**ON-SITE SEWAGE DISPOSAL SYSTEM
 HOWARD COUNTY HEALTH DEPARTMENT
 BUREAU OF ENVIRONMENTAL HEALTH**

Van Sant Plumbing & Heating IS PERMITTED TO INSTALL ALTER
 ADDRESS: 3 North Main Street, Mount Airy PHONE NUMBER: 800-682-6726
 SUBDIVISION: Fox Creek LOT NUMBER: 25
 ADDRESS: 12328 Fox Meadow Lane PROPERTY OWNER: NVR., Inc.
 SEPTIC TANK CAPACITY (GALLONS): 1250 OUTLET BAFFLE FILTER REQUIRED
 PUMP CHAMBER CAPACITY (GALLONS): N/A COMPARTMENTED TANK REQUIRED
 NUMBER OF BEDROOMS: 4
 SQUARE FEET PER BEDROOM: 180
 LINEAR FEET OF TRENCH REQUIRED: 3' 10/23/03 KN 240 HOUSE SERVED BY PUBLIC WATER

WALL CHECK
LOT 25
FOX CREEK SUBDIVISION

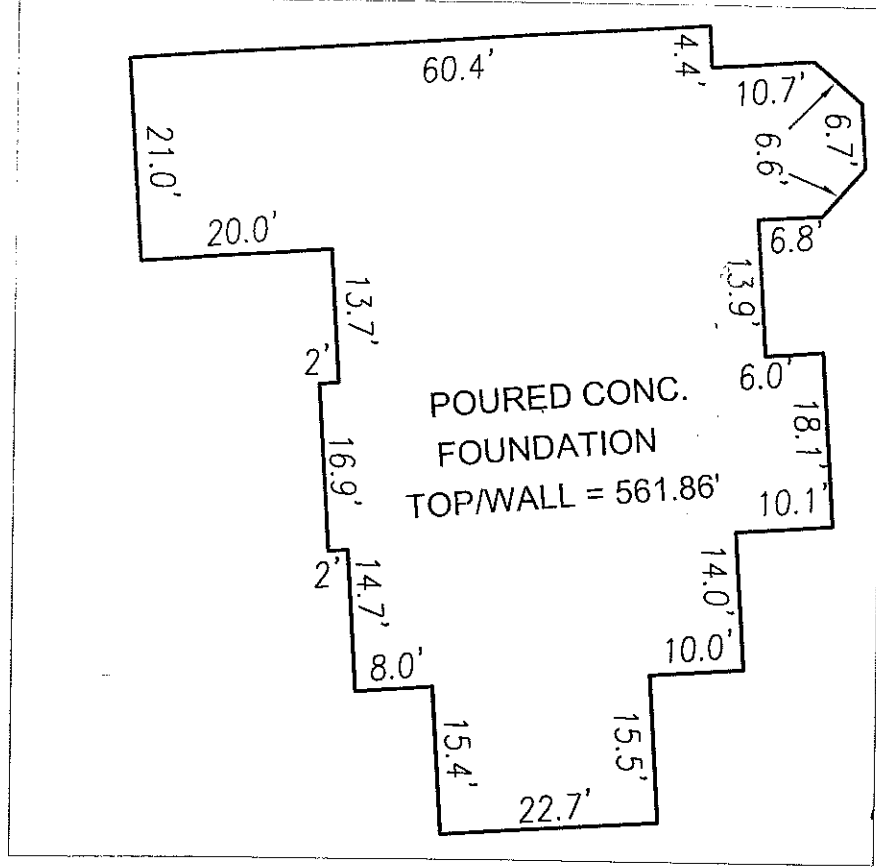
PRE-CONSTRUCTION 10/21/03 upper right stake missing & other stakes incorrect. Call NV Homes to restake. Do Not Start. (KN) 10/22/03 Van Sant
 INSTALLATION called to verify stakes in. (KN) 10/23/03 House has rotated more clockwise but no effect on dist. to SDA. May relocate tank to right side of yard & slightly downhill toward d. box for room of future deck. OK TO BEGIN (KN) 10/27/03 tank / DBox + 2 60' trenches in; OK to cover work completed. (KB/SD) 10/29/03 - OK to cover all work (SD)

FOUNDATION DETAIL
SCALE: 1"=20'

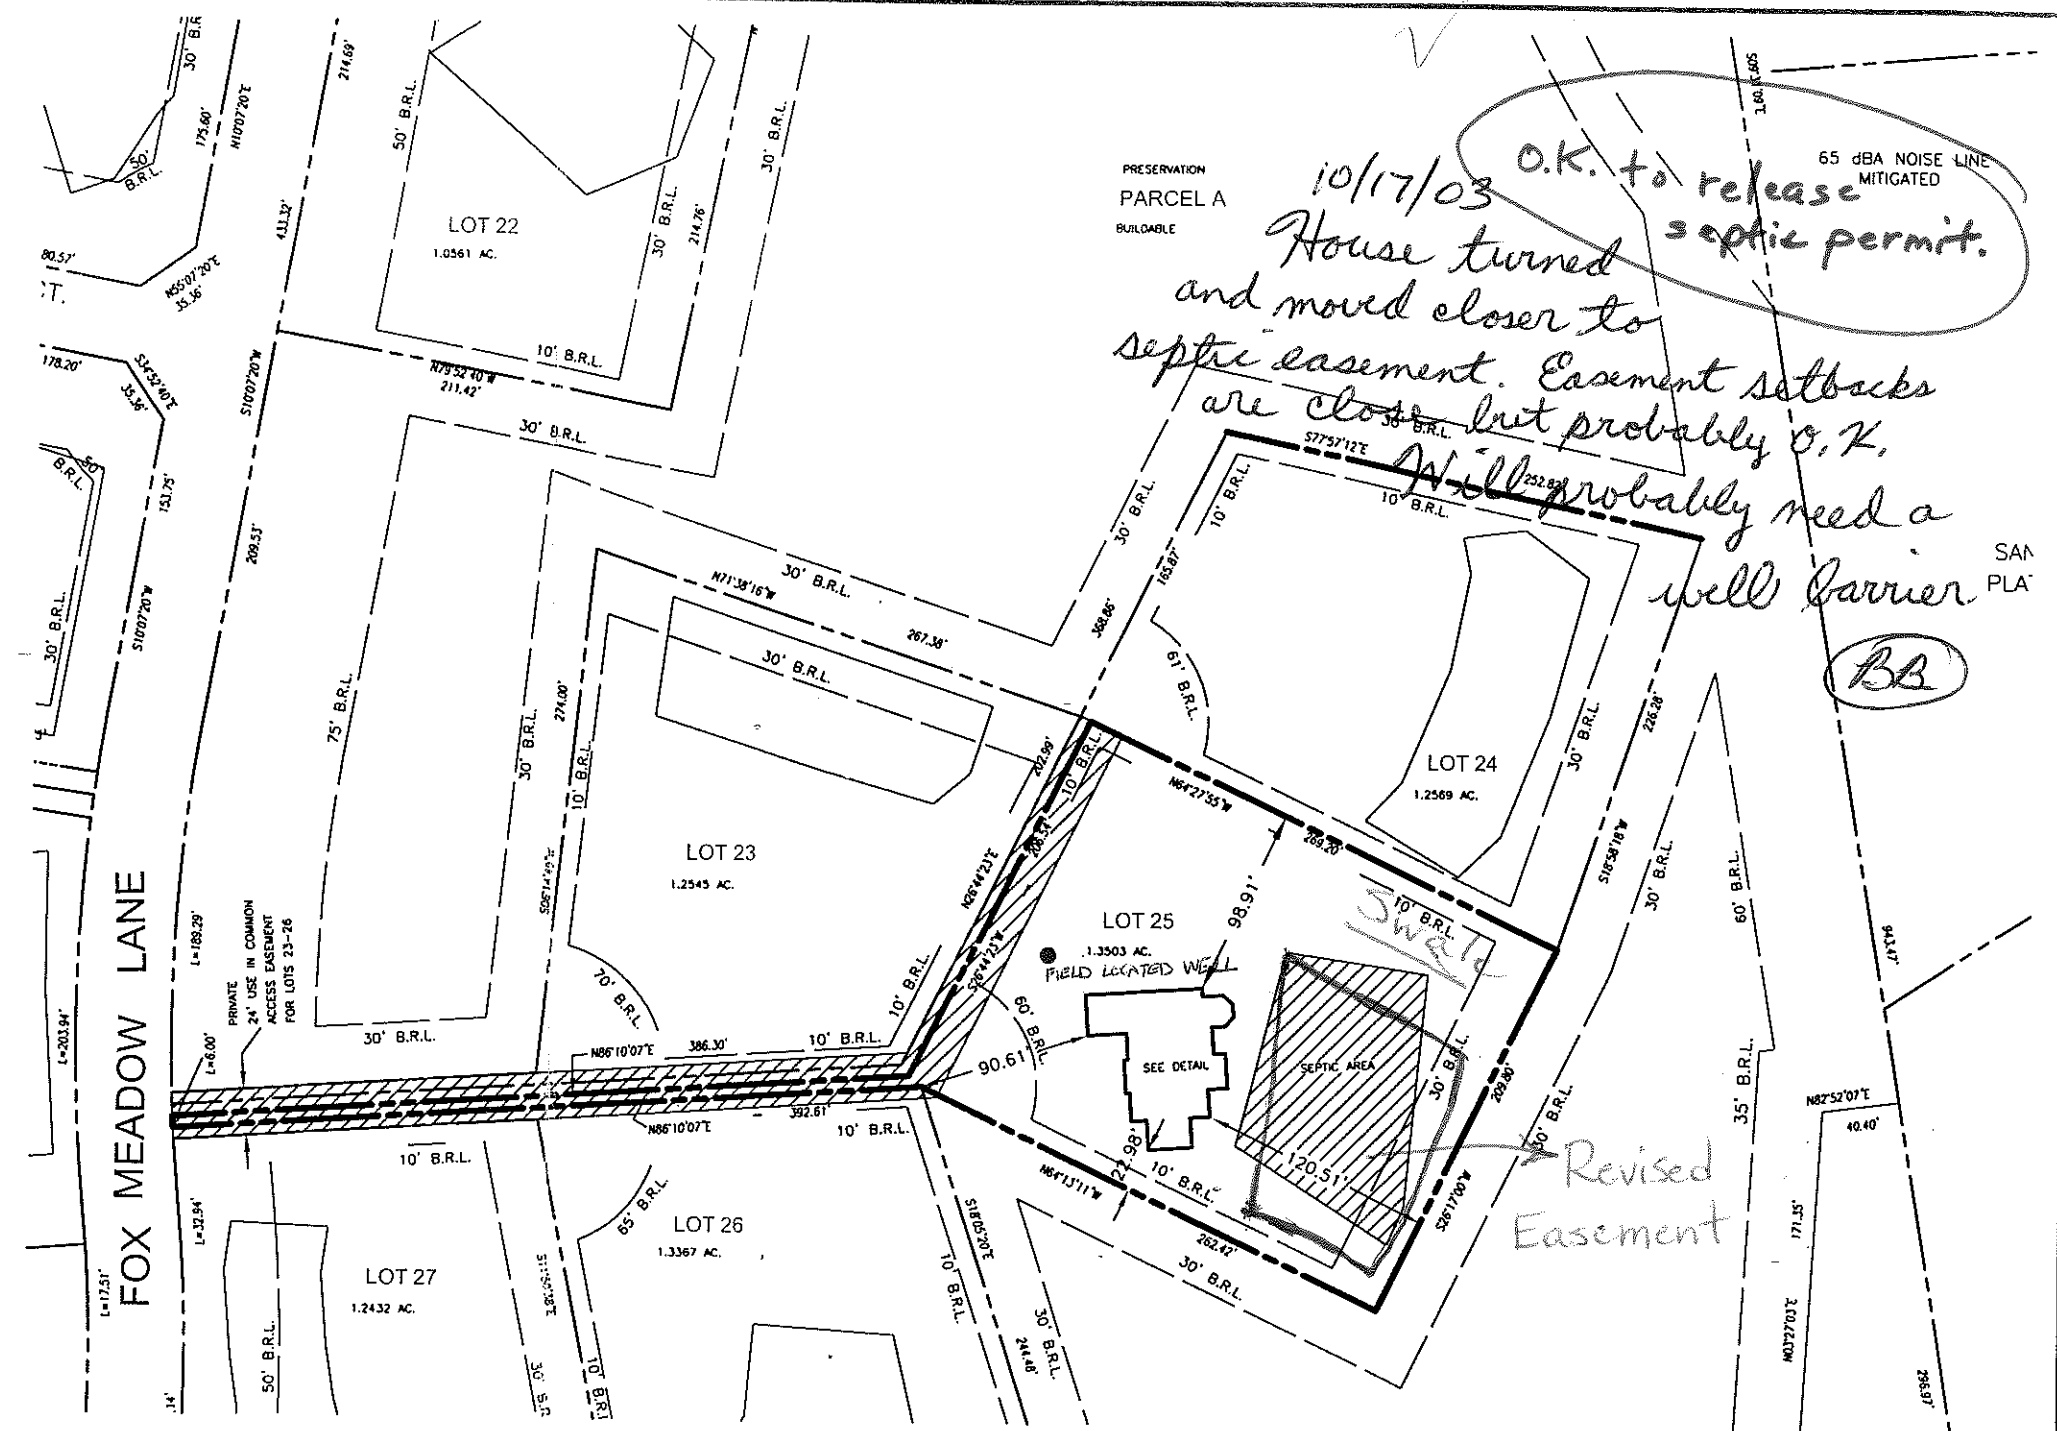
10/17/03 O.K. to release
House turned and moved closer to
septic easement. Easement setbacks
are close but probably O.K.
Will probably need a
well carrier
BB
